notes.md

So many problems... ;/

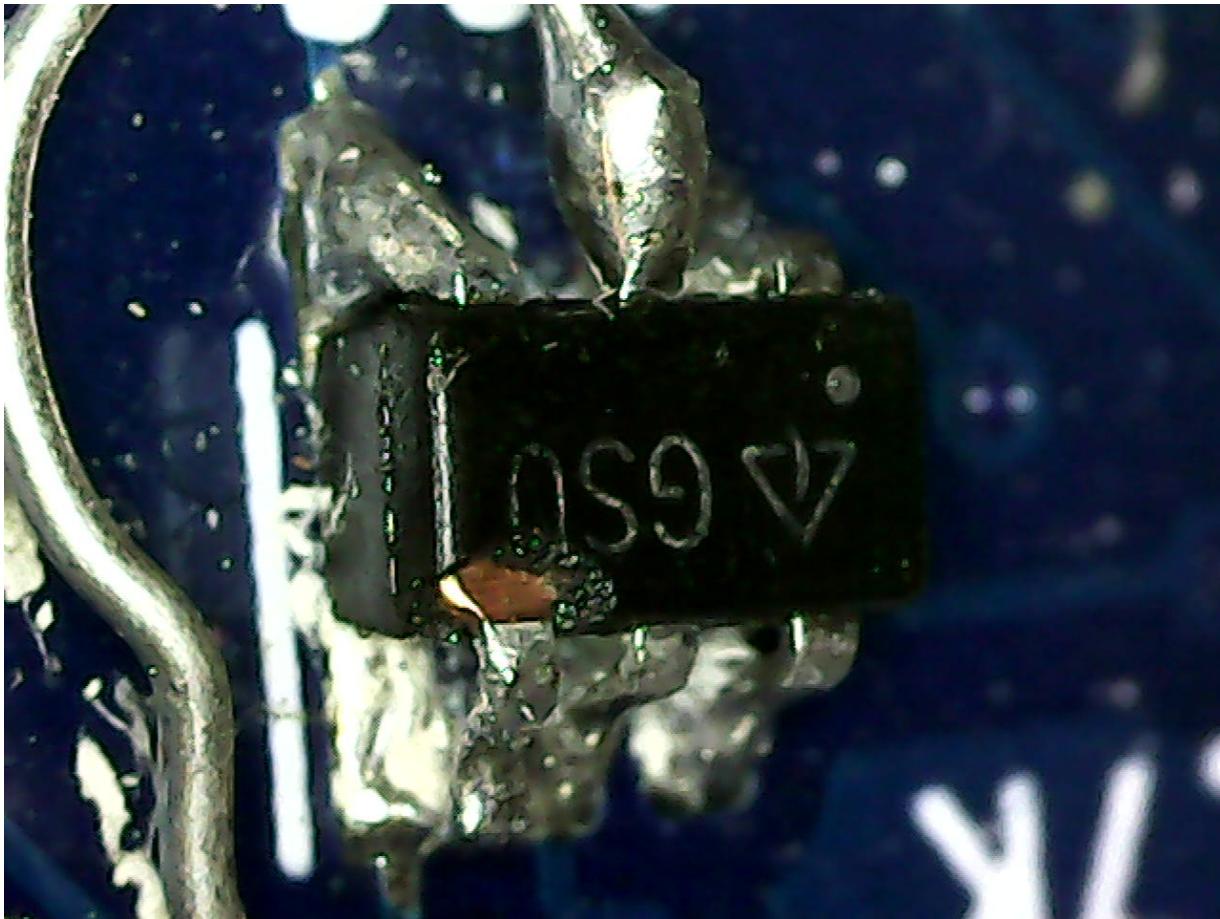
1. missing ground on the resistor, needed to bridge
2. this circuit doesn't work at all because mosfets work on voltage differences, and they aren't perfect diodes + transistors were rotated incorrectly anyway. Now it's working that when you connect charger, the circuit turns itself on, it's only charging (which is ironic, explained later)

3. There are 2 packages of this chip, i ordered SOT6 but used SOT5 pinout (its diffrent for a reason...) so those 2 red pins need to be lifted, and the bottom one bridged

4. this pin needs to be pulled to 3.3V

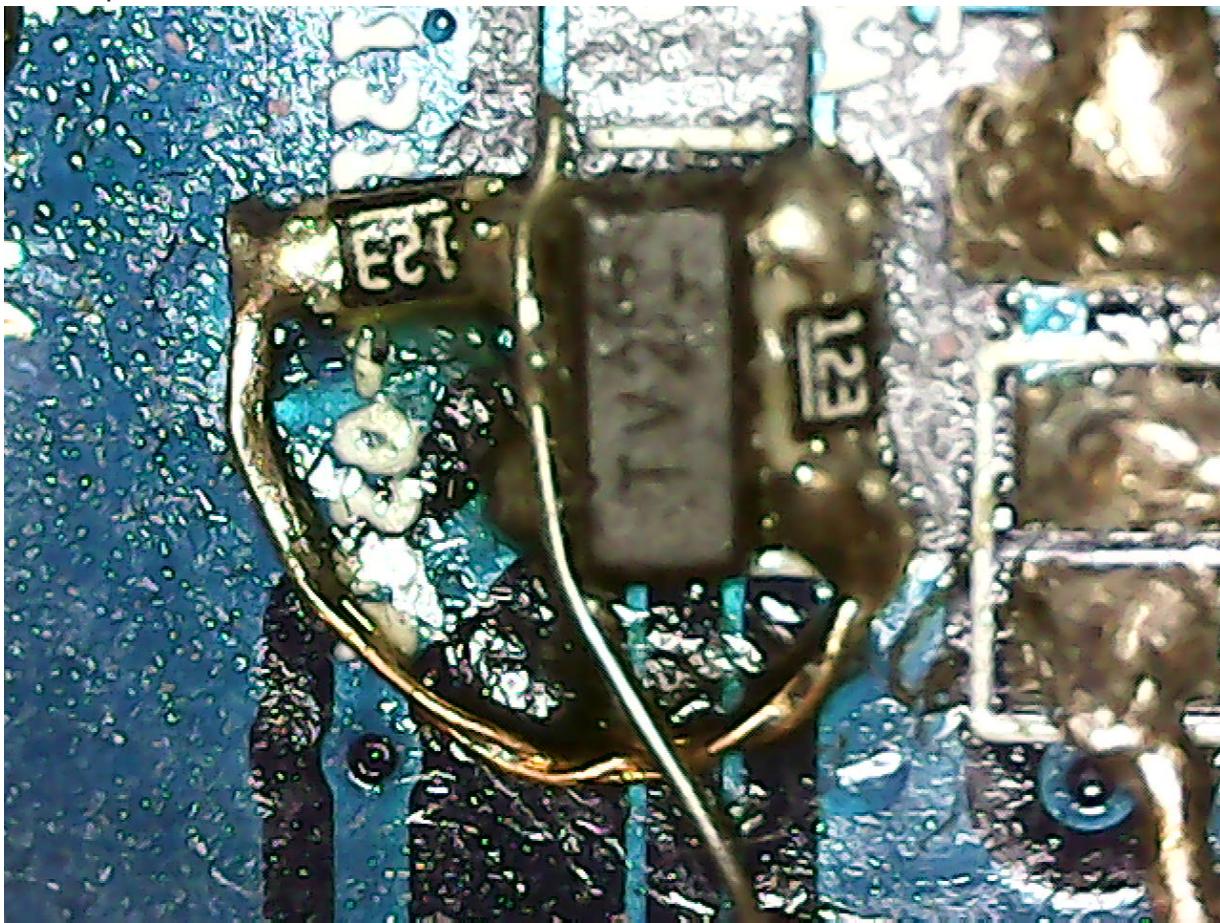
5. Stupidest design error - this pin needs to be, after a 1.8k resistor connected to the data line, in 5.1 it is shown, and only "orange" paint makes contact. Here is a better picture:

6. To make a good, but without glue connection with the bottom case; goldpins, solder and holes in the part were used. Works good

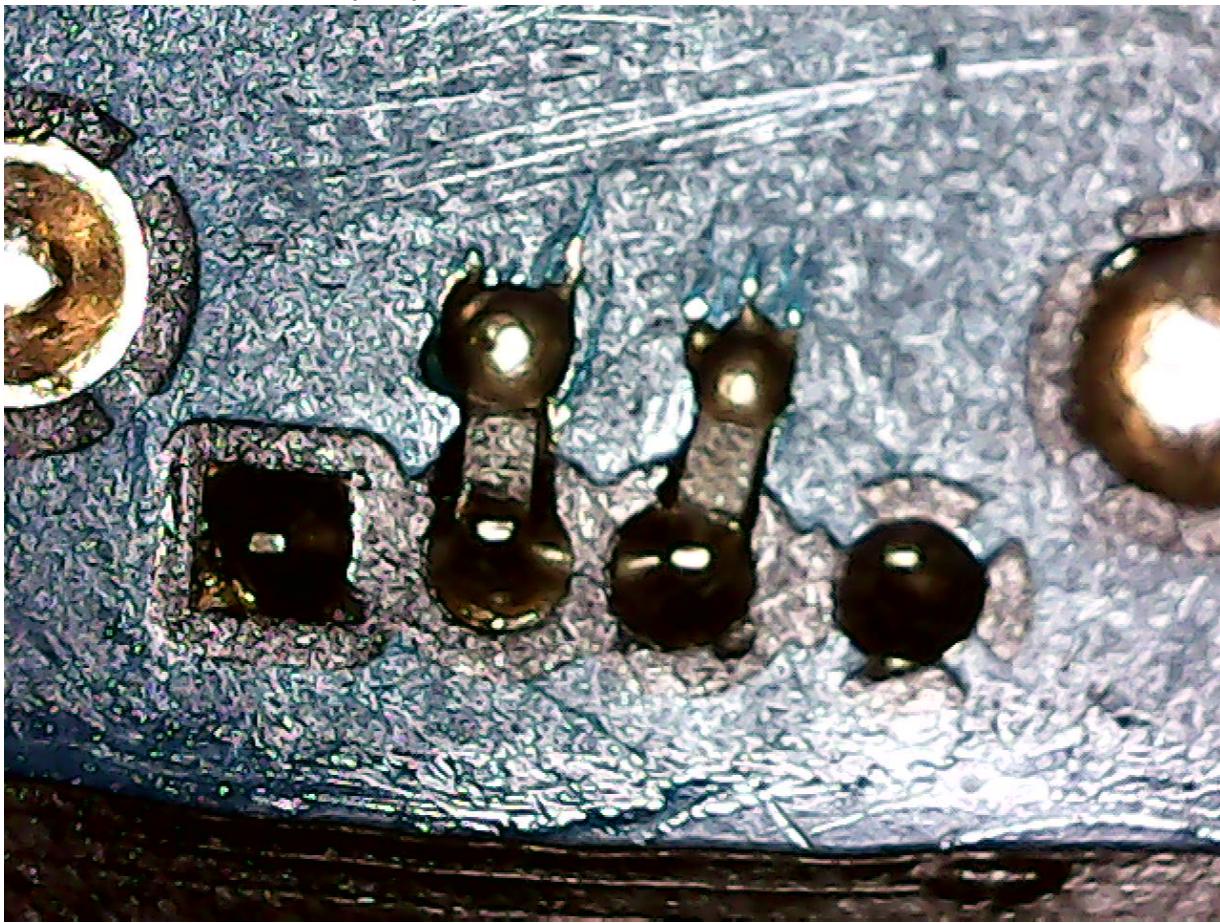
7. Biggest problem to figure it out to work: host data lines should be pulled to GND with 12k resistors, and peripherals with 10k

8. If not THT micro usb ports are used, use some epoxy to make it stronger
